Case 23161: Appeal Hearing Level I Site Plan Approval 6459 Bayers Rd., Halifax

Regional Centre Community Council

① Render View - Bayer's Rd

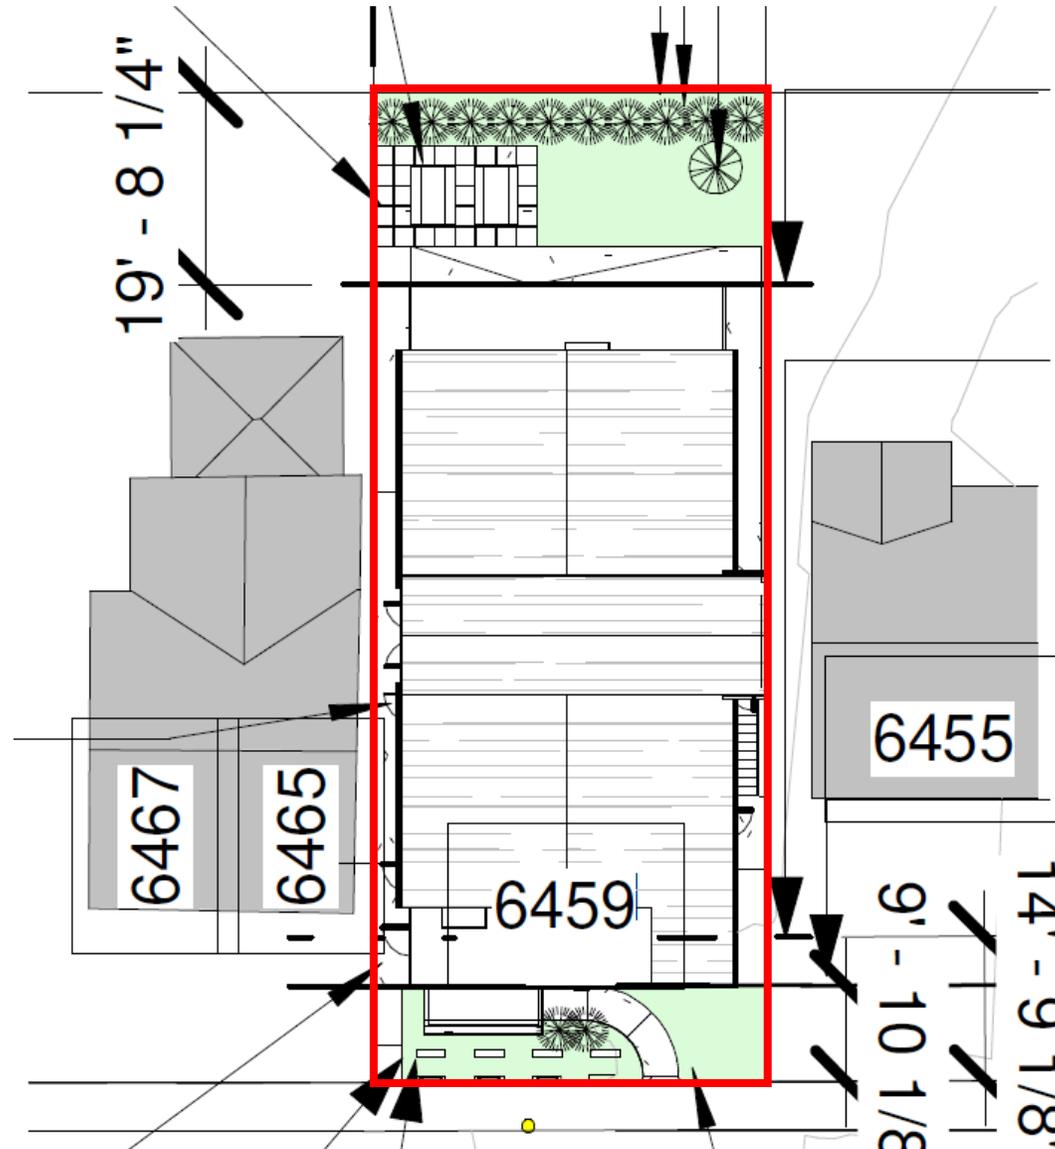
- No dimensions given for the walkway connecting the at-grade private open space for the unit fronting Bayers Rd.
- Relationship of the building to the street could be improved by having a deeper front patio for the unit fronting Bayers Rd. This would better relate to the street and improve the usability of this space particularly for persons with mobility challenges

- We are seeking clarification on the calculation used to determine the amount of glazing required. Assuming the entire width of the ground floor façade relates to the grade-related unit, the 50 square foot of glazing provided by the one window and door would not meet the minimum requirement of 25%.

- It is unclear if the doorway and stairs shown on the front elevation is a common access or not. We have concerns about the type of lighting being proposed as this has the potential to directly impact neighbouring properties. The main shared entrance is located on the side of the building and immediately adjacent to the existing residence and lighting for the private open-space in the rear yard could impact all abutting properties.

- The open space in front of the grade-related unit is a patio, which is a required part of the building for an at-grade unit, not an at-grade private open space, and does not have to meet the 2 metre pedestrian access requirement.
- Accessibility considerations are contained within the building code, not the land use bylaw, and will be addressed at permitting.

- A portion of the building along the streetwall is used for common building utility or storage purposes. Based on the area of the remaining portion of the streetwall, 4.4 square metres of glazing is required, and the proposal includes 4.6 square metres of glazing, which meets the requirement.

- The building entrances on the front elevation are not common entrances, and are not required to be illuminated. The LUB prohibits light from being directed towards streets or adjacent properties, and requires the use of full cut-off lighting fixtures. As lighting this is not a design requirement, it will be a confirmed as part of the permit review.
